Technical Service Bulletin: TSB101093

New Water Pump O-ring Adapter

New O-ring Adapter, Part Number 3644172

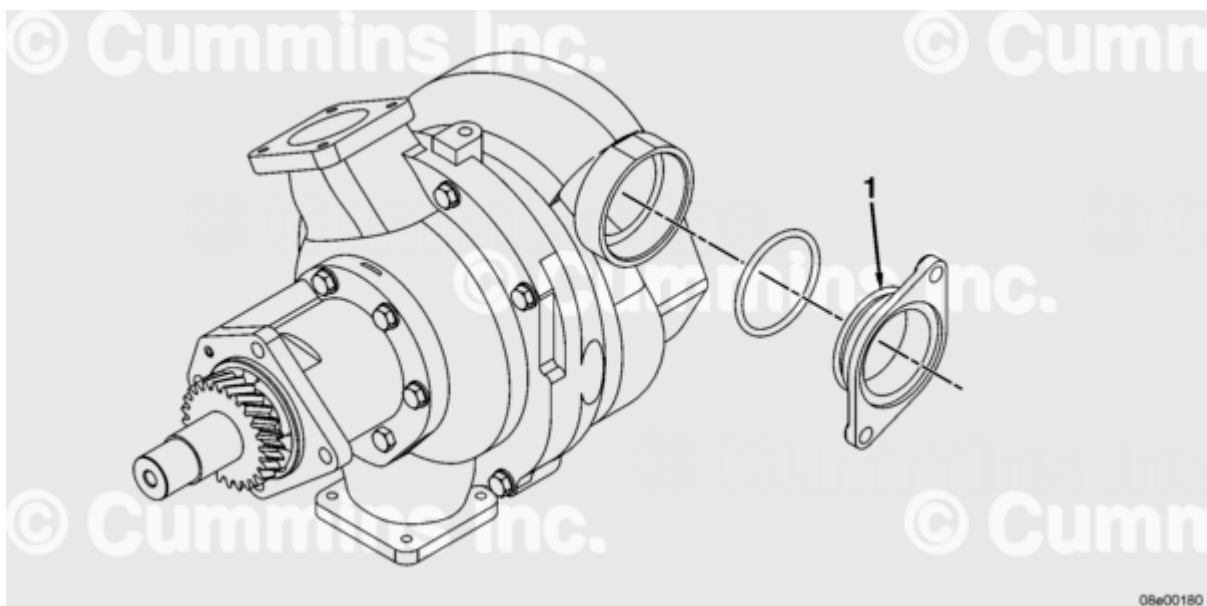
This document announces the release of a new o-ring adapter for QSK38/50/60 MCRS water pumps. The new o-ring adapter obsoletes the previous part number. A dimensional change was made in the o-ring groove to improve the sealing properties of the joint at low temperatures.

This change was made to all dual impellor water pumps fitted to QSK38/50/60 MCRS engines, water pump options WP 6704, WP 6705, WP 6707, WP 6708, WP 6713, WP 6714, and WP 6718. The ESN first for this change was 33183776, built on November 8, 2010.

Previous O-ring Adapter Part Number	New O-ring Adapter Part Number
4951852	3644172
